CITY OF LA VISTA
MAYOR AND CITY COUNCIL REPORT
OCTOBER 18, 2016 AGENDA

Subject:	Type:	Submitted By:
PUD SITE PLAN APPROVAL — LOT 9, SOUTHPORT EAST REPLAT SIX (NE OF SOUTHPORT PKWY & GILES RD)	◆RESOLUTION ORDINANCE RECEIVE/FILE	ANN BIRCH COMMUNITY DEVELOPMENT DIRECTOR

CASE NUMBER: 2016-PUD-05

RE: PUD Site Plan - Initial Review
Lot 9, Southport East Replat Six

Emergency Vehicle Turn Template

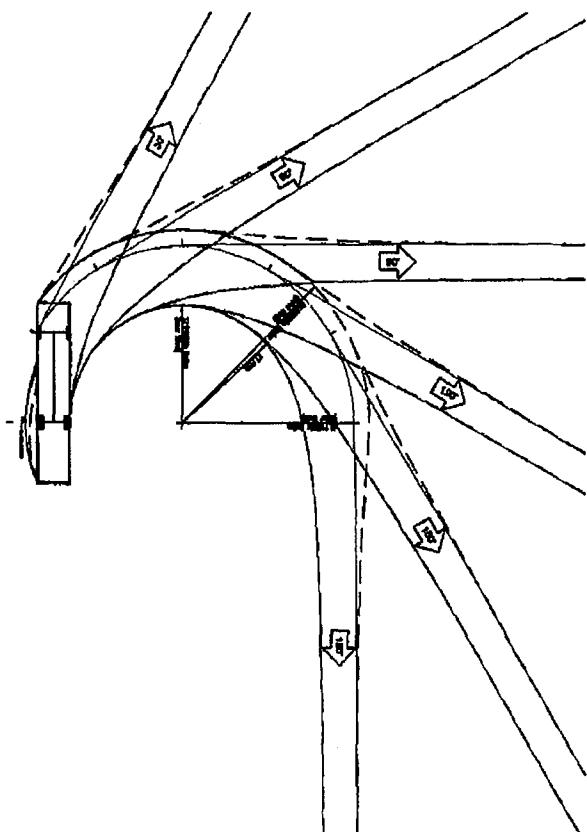
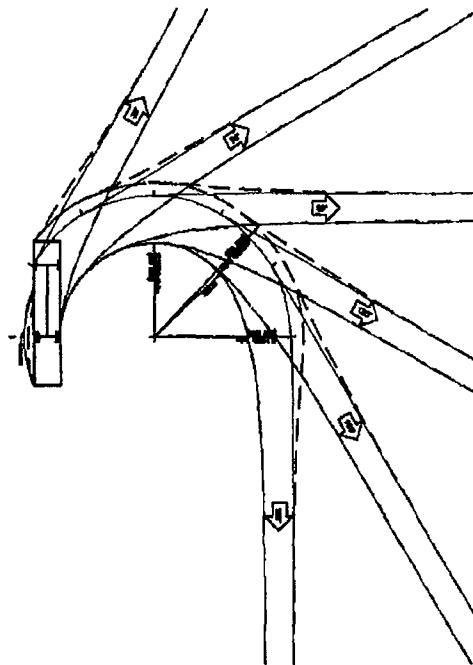
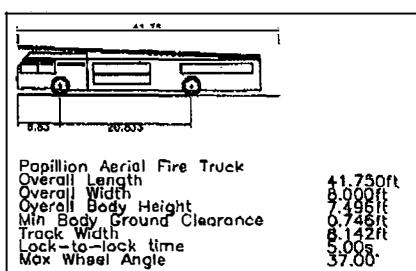
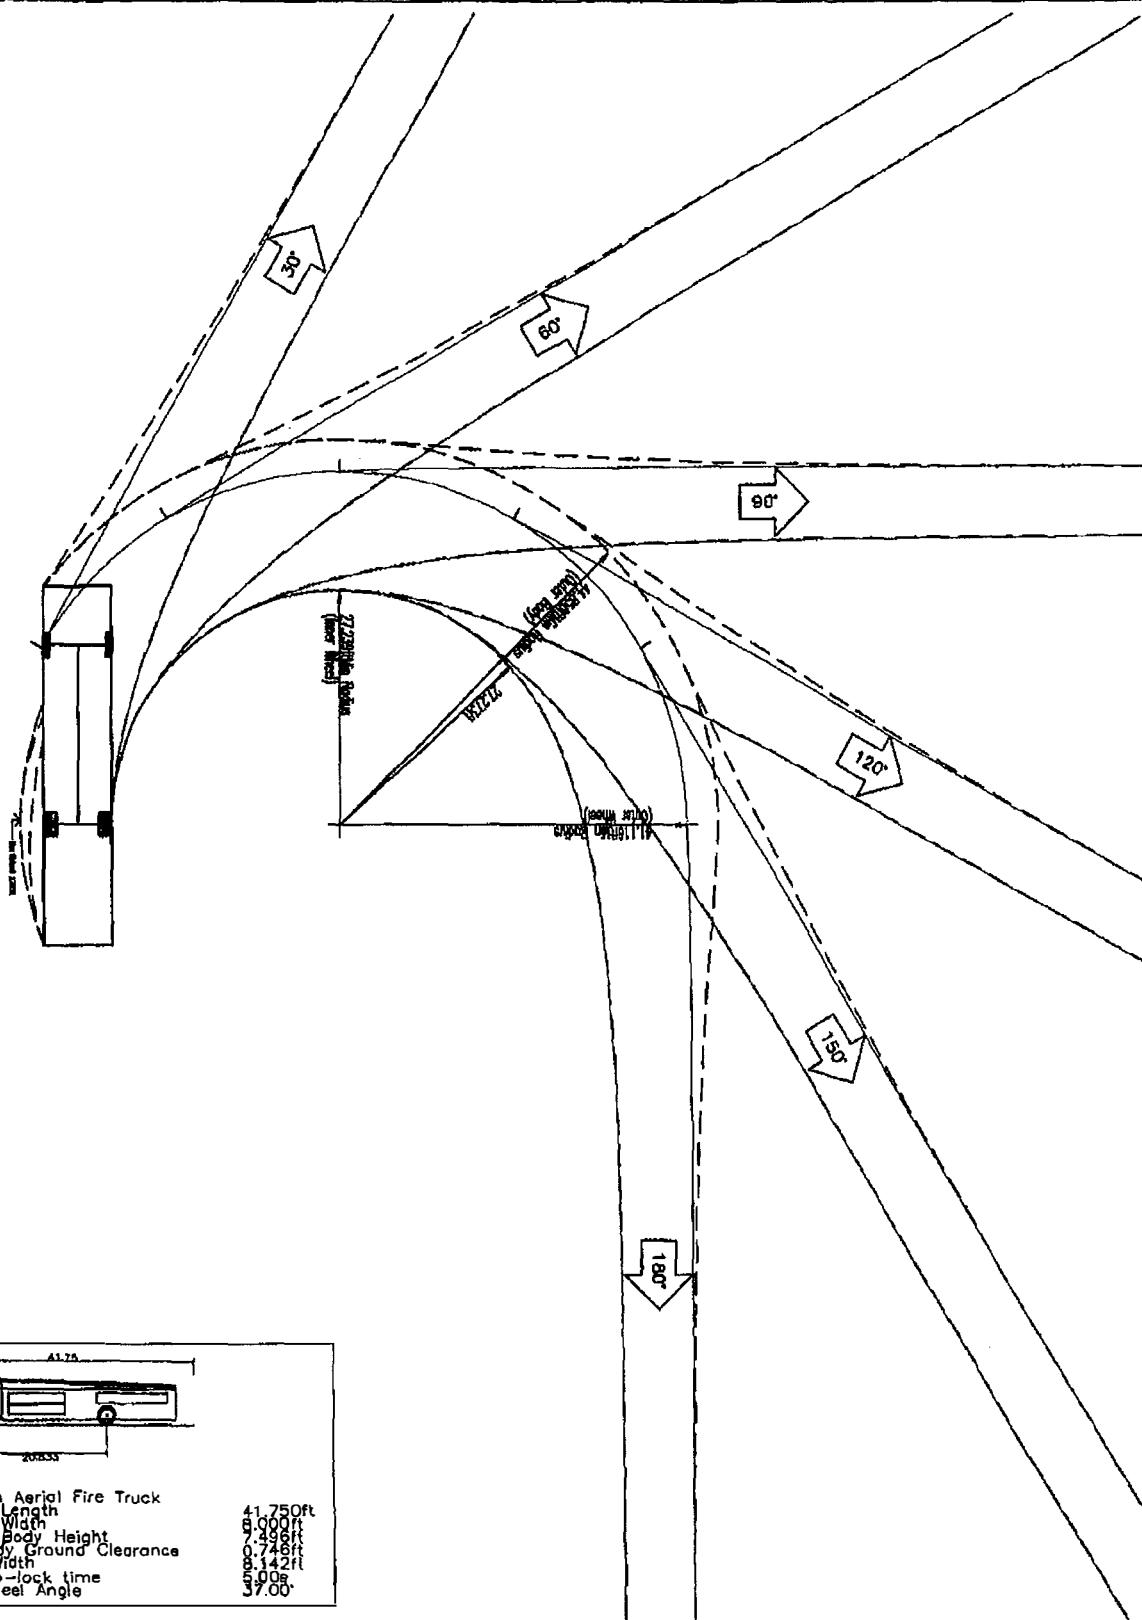
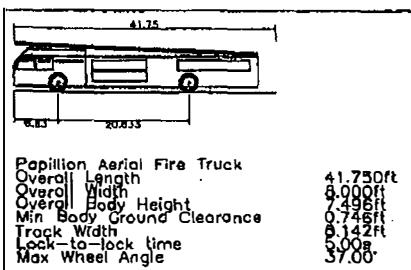
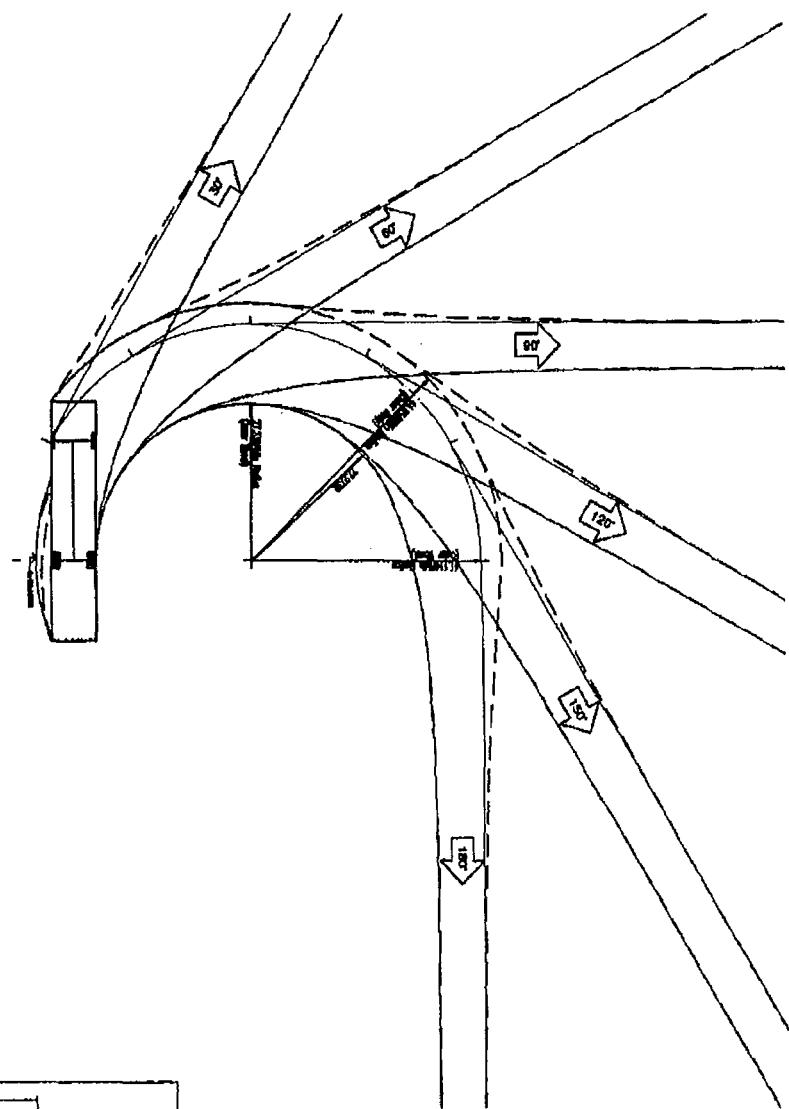
3. In regards to Article 5.15.04.04, Sheet 2 of the plans needs to have existing fire hydrant locations shown that provide coverage for this building. Also, the Emergency Vehicle Plan does not depict the apparatus dimensions. Additional information from the Papillion Fire Department has been included for your review.

3. Comment #3 - Existing fire hydrant is shown and the emergency vehicle plan (Sheet 2) has been revised to match the proper truck size & turning radii per the Papillion Fire Department.

3. The revised plan set has been reviewed by the Fire Marshall and the revisions have met his approval.

EXISTING CONDITIONS AERIAL IMAGE

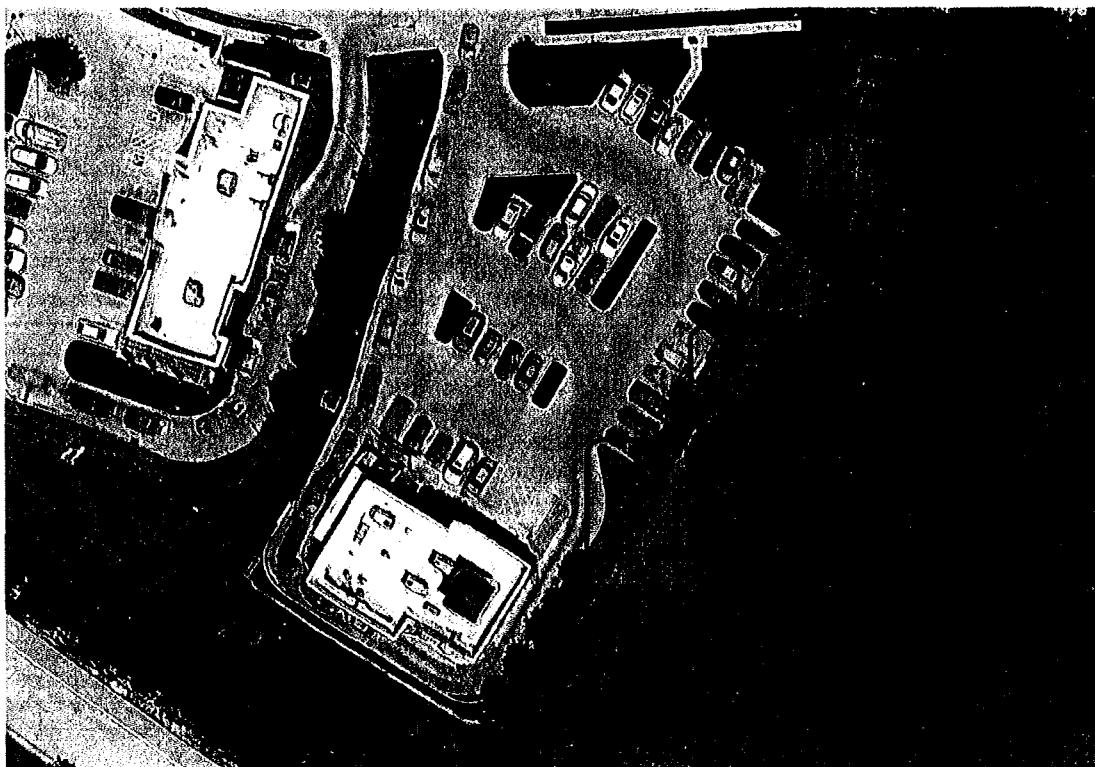
4. The new proposed landscape groupings on the east property do not appear to take in to account the existing plantings previously installed by Runza. The proposed groupings should be adjusted to fill the gaps between Runza's groupings and give adequate distance between existing and new trees. Refer to the existing conditions aerial image below demonstrating how Runza and Burger King handled their adjacent groupings to provide a continuous screened condition, and also highlighting the potential current gaps along the referenced east property line.
